## Determination 2019/058

# Regarding the durability of steel sub-floor bearers installed in four houses that have been built in respect of building consents issued on the basis of national multiple-use approvals

### Summary

**Figure 2: Typical sub-floor construction for all four buildings**

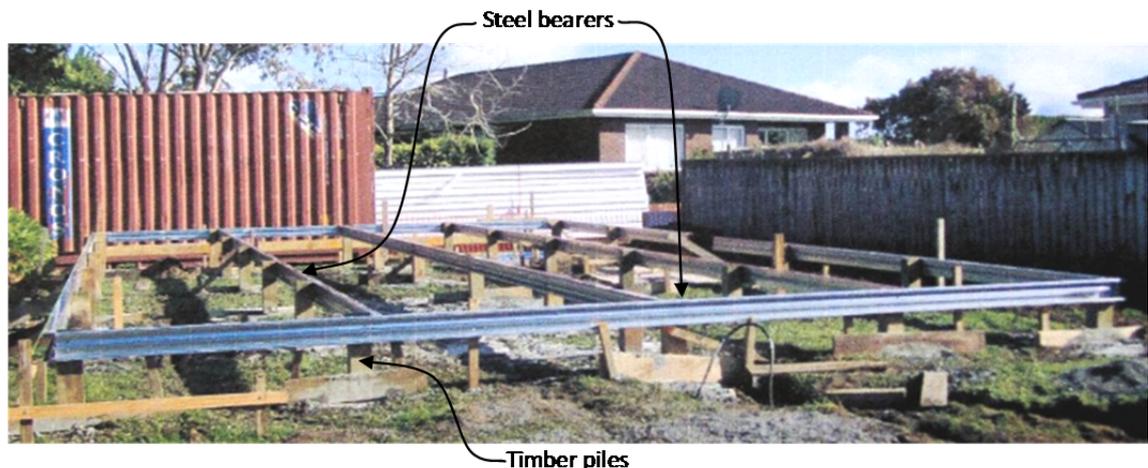
- when a purlin C-section is used as a bearer, its durability is compromised as its bottom flange can collect debris and condensed moisture, with the inspection photographs showing both building debris and speckle rust on installed steel bearers

- bottom of C-sections with rust, timber swarf and debris
  - other areas with surface rust, which was later painted over
  - bearers had been touched up ‘by spraying over the rust that could be reached via the limitation of the crawl space and limited accessibility to the entire beam.’

- Photographs of unpainted bearer in Marton showed surface rust due to swarf after only a few days, which raised the authority’s concern, although the swarf was subsequently cleaned off.

Figure 3: The sub-floor construction

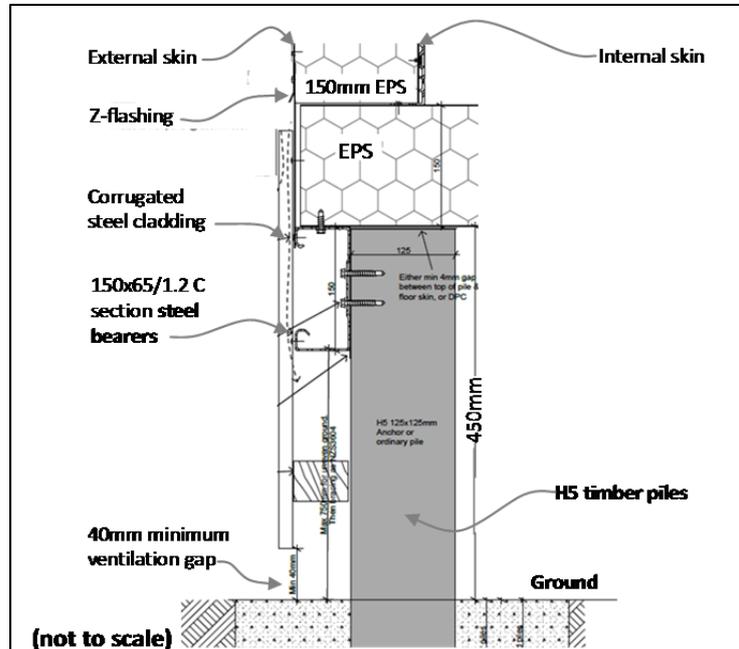
- In regard to the deck detail:
  - the outer perimeter steel bearer is exposed to moisture below the deck from rainwater, resulting in partial ponding on its bottom flange

- the height provides access to parts of the bearers, but not to the top and parts of the back of the bearers without being removed – it is not acceptable to just repaint those steel areas that are able to be accessed

- a) The bearers must perform to a life of 50 years, as the bearers provide structural stability, are difficult to access or replace (refer to drawing 401<sup>27</sup>), and failure to comply with the [Building Code] would go undetected during normal use and maintenance of the building;
- b) The specifications identified in [tables in the Durability Statement]<sup>28</sup> are given in respect of purlins, not bearers, and do not perform to a life of 50 years;
- c) Even applying the most restrictive durability specification contained in the Table [2] (for Zones 3 and 4) bearers would require re-coating every 15 years to a level of P1 and P2 in accordance with specifications at Table 1<sup>29</sup> on pg. 12 (A10125);
- d) The reasons given in [paragraph 3.4 of this determination in respect of the expert’s report] ...
